TR-103 - Corrective Action Response to Comments

**Re: Permit No. M-1980-244;Cripple Creek & Victor Gold Mining Company; Cresson
Project; TR-103 Non-Compliance Corrective Action Response to Comments**

Subject: Stability Analysis of an Upset Condition around the Booster Pump

NewFields		CLIENT CRIPPLE CREEK & VICTOR GOLD MINING COMPANY	
PROJECT		CRESSON PROJECT, PERIMT NO. M-1980-244; TR-103 NON-COMPLIANCE CORRECTIVE ACTION RESPONSE REGARDING VLF2	
TITLE		VLF2 SLOPE STABILITY AT BOOSTER PUMP	
		FILENAME 0106.054.001F	
		FIGURE NO. 1	REVISION A

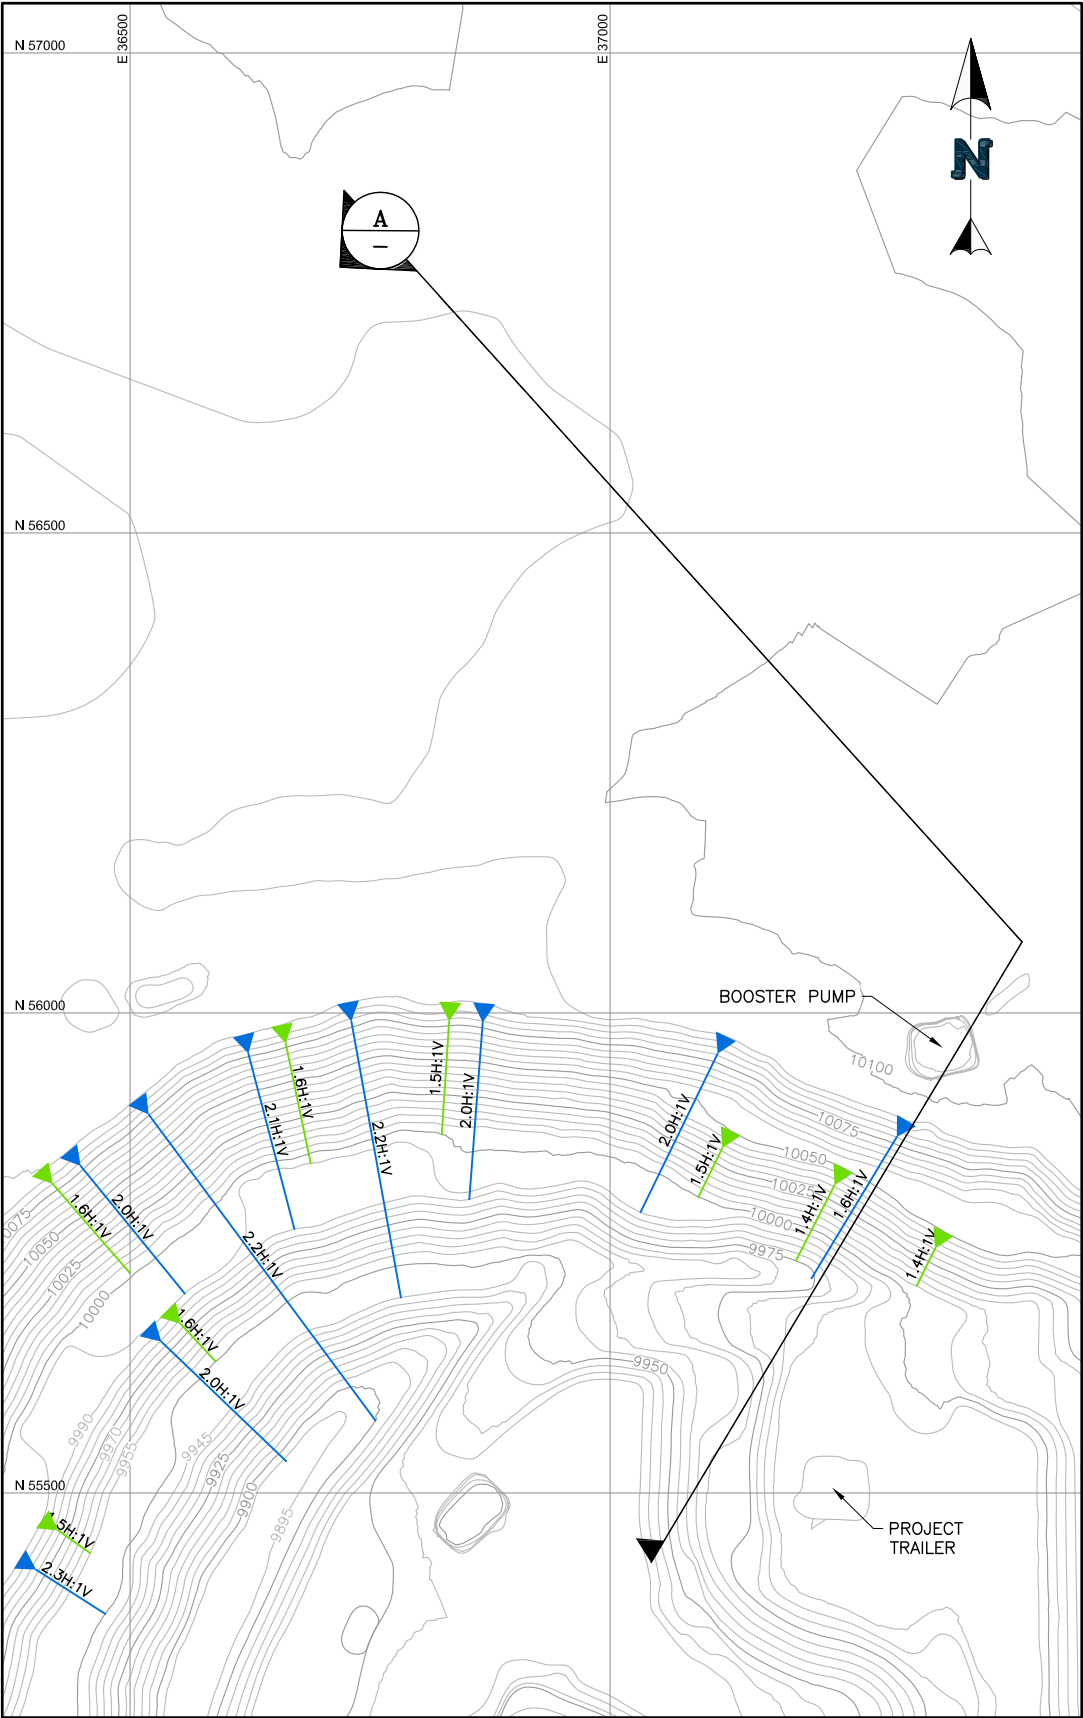
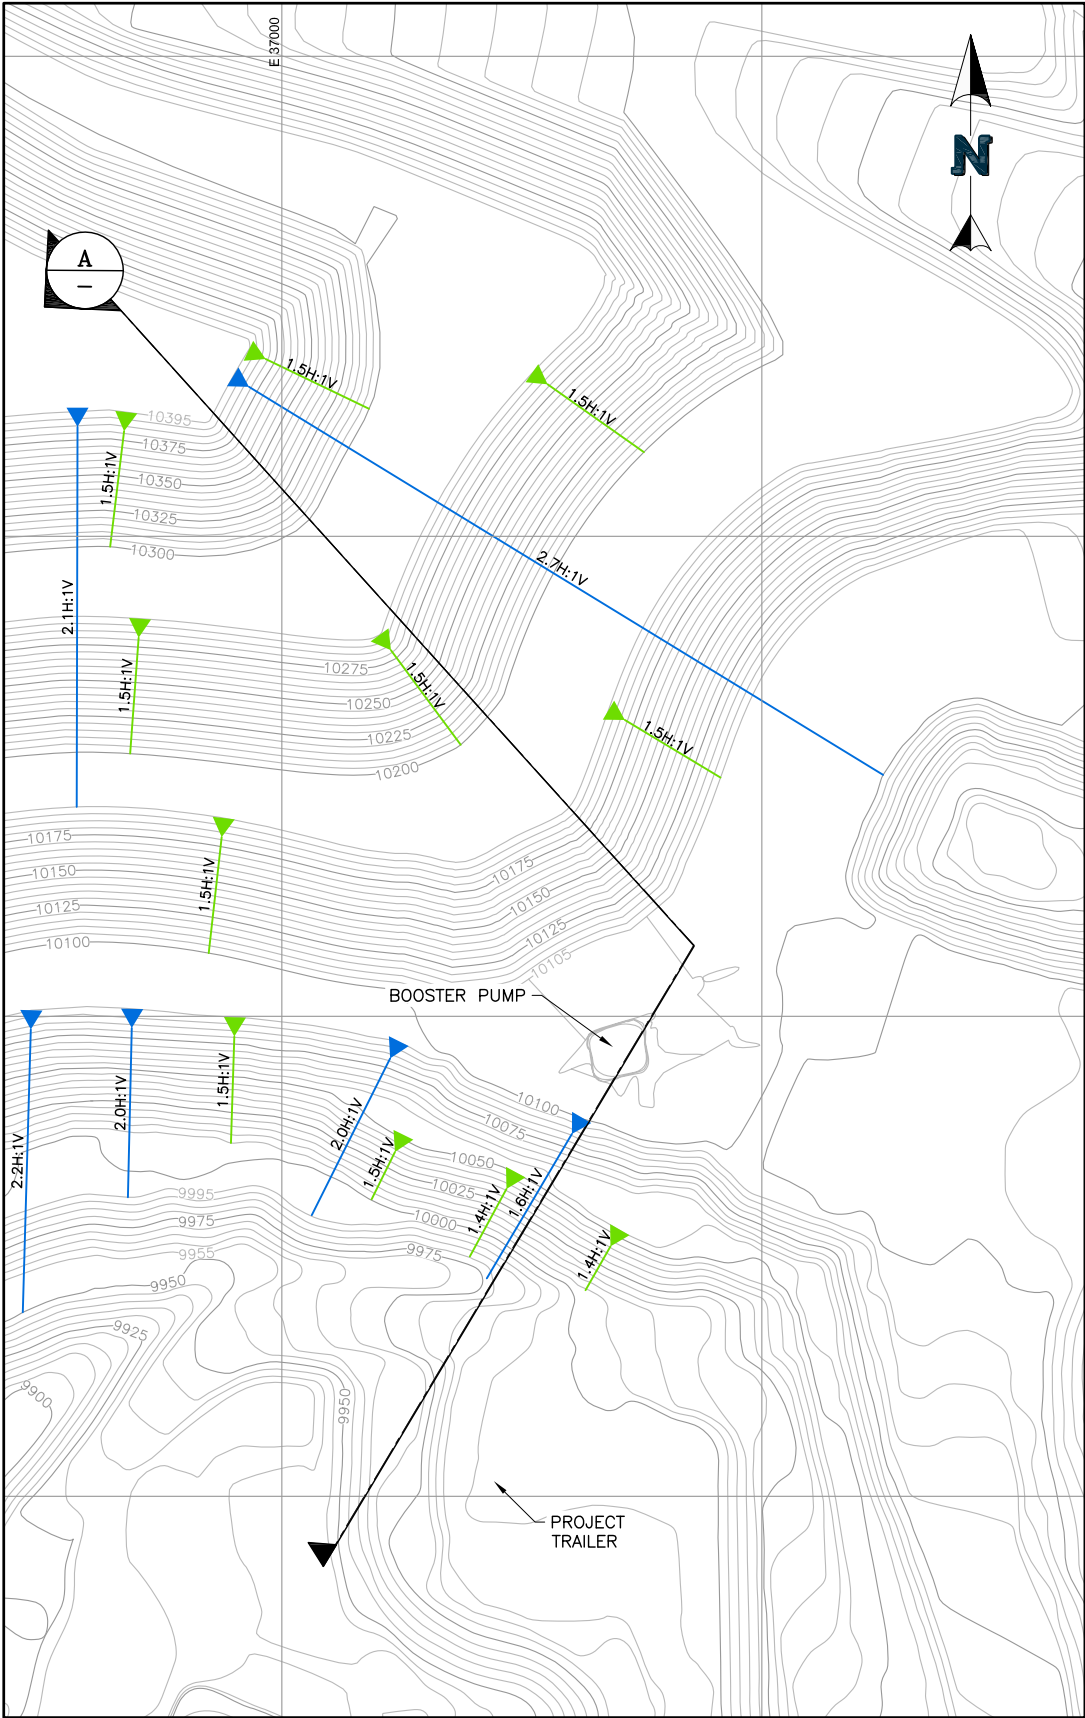
1. *Division comment: How long is it expected to take to place additional lifts above the booster pump building to “flatten” the overall slope?*

2. *Division comment: Provide a slope stability analyses for the slope below the booster pump building based on the Mined Land Reclamation Board’s Policy No. 30 for both the existing slope and the expected final slope. The analyses should include worst case conditions for normal leaching and address the stability should there be a process solution breach in the vicinity.*

The additional lift around the booster pump station will commence in the first quarter 2023 at the current forecasted mining rates and should take approximately 6 months to complete.

Figure 1 shows the current heap configuration and the future heap configuration. The Booster Pump is sited on the 11000' bench of VLF2, north of the Mill. The downhill heap slope near the pumps was over steepened to an overall slope of 1.6H:1V to facilitate the construction of the Booster Pump and associated infrastructure. The pump is in line with a 24-inch diameter pipeline which has the flow capacity of 16,000 gallons per minute (gpm). Based on our understanding of the current and future leaching plan in the vicinity of the booster pumps is that the slopes below the booster pump were leached prior to the installation of the pumps and there are no plans to leach the slope below the booster station in the future.
